UNITED STATES
NUCLEAR REGULATORY COMMISSION
WASHINGTON D. C. 20555

MEMORANDUM FOR: D. G. Eisenhut, Assistant Director for Operational Technology, Division of Operating Reactors

FROM: W. R. Butler, Chief, Plant Systems Branch
Division of Operating Reactors

SUBJECT: REVIEW OF IGF INSPECTIONS OF OPERATING PWRs RELATED TO THE FOLLOW-UP ACTIONS IDENTIFIED IN NUREG-0138 ISSUE NO. 4, "LOSS OF OFFSITE POWER SUBSEQUENT TO MANUAL SAFETY INJECTION RESET FOLLOWING A LOCA"

Modified RESAR 3S Figure 15.4-28. Peak Clad Temperature - DECLG ($C_D = 1.0$) (NRC Parameters)

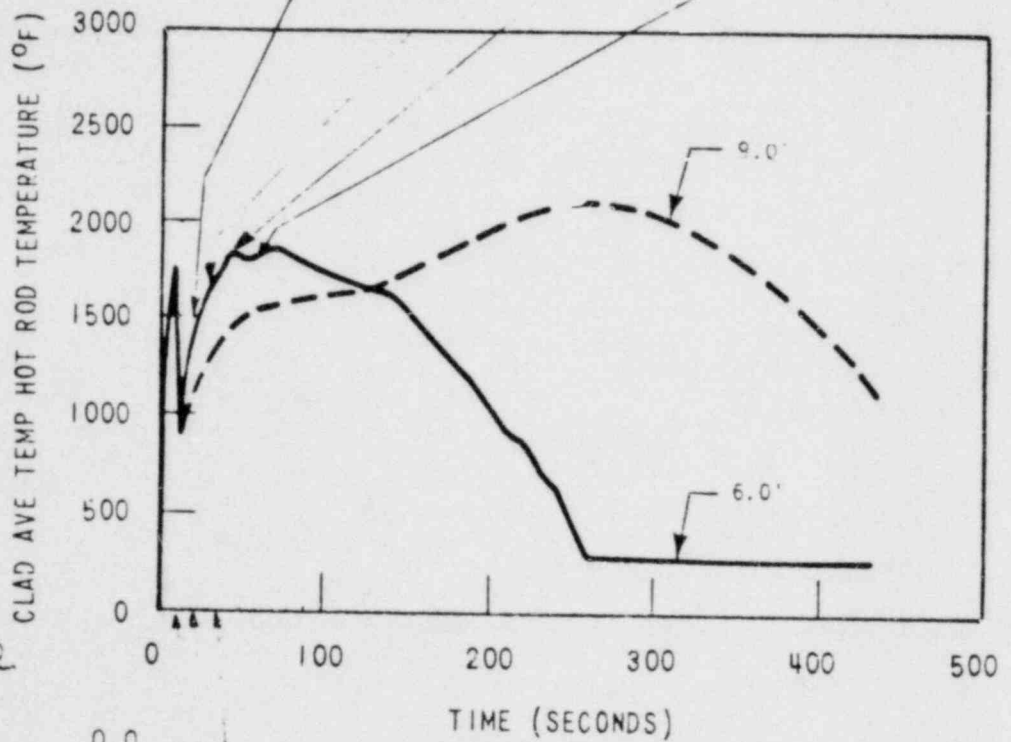
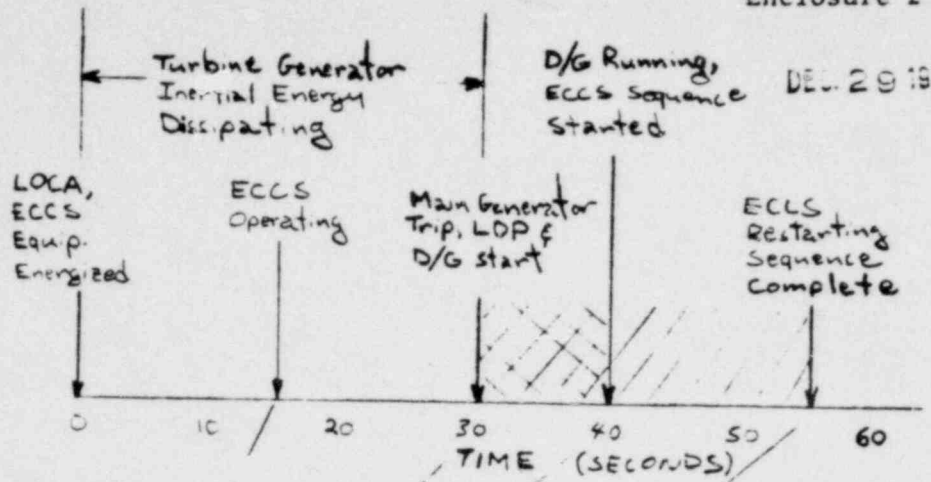
In our normal LOCA analyses we assume that a loss of offsite power occurs simultaneously with a LOCA. Although this is a conservative assumption, it may be less conservative and less realistic than assuming that the loss of offsite power is delayed until 15-90 seconds after the LOCA. This sequence is more likely because the effects of the disturbance to the utility grid system resulting from the LOCA do not occur until the main generator inertial energy has been dissipated and it finally trips. It is during this time period that it is necessary to reflood the reactor core following a blowdown of the reactor coolant system. This sequence of events is illustrated in Enclosure 2.

Any significant delay in reflooding the core could increase the peak fuel clad temperature resulting from a LOCA. The time delay in reflooding the core while waiting for the diesel generators to start after a loss of offsite power is shown in Enclosure 2 as the cross hatched area between 30 and 40 seconds. This time delay could be eliminated by automatically starting the diesel generators when an SIS signal is initiated. It should be noted, however, that this would not eliminate the time delay in reflooding the core while waiting for ESF loads to restart when a LOCA is followed by a delayed loss of offsite power.

Based on these considerations we believe that the NRC staff should perform a sensitivity analysis to verify that short interruptions of cooling water flow to the core during the reflood period for the time necessary to complete the ECCS starting sequence will not have unacceptable consequences. This sensitivity analysis is necessary because the probability of a loss of offsite power as a result of a LOCA is highly sensitive to many variables and conditions and may be highest at about the beginning of the reflood period due to a delayed main generator trip.

In the interim, while the sensitivity analysis is being performed, we believe that all operating reactors should have control systems which automatically start the diesel generators on both a loss of offsite power and a SIS, unless the licensee can show that such action is not in the best interest of safety and that the time delay to start the diesel generators will not result in unacceptable consequences from a LOCA. This position should affect only a very few operating reactors and can be implemented on a routine basis as part of the follow-up actions recommended below.
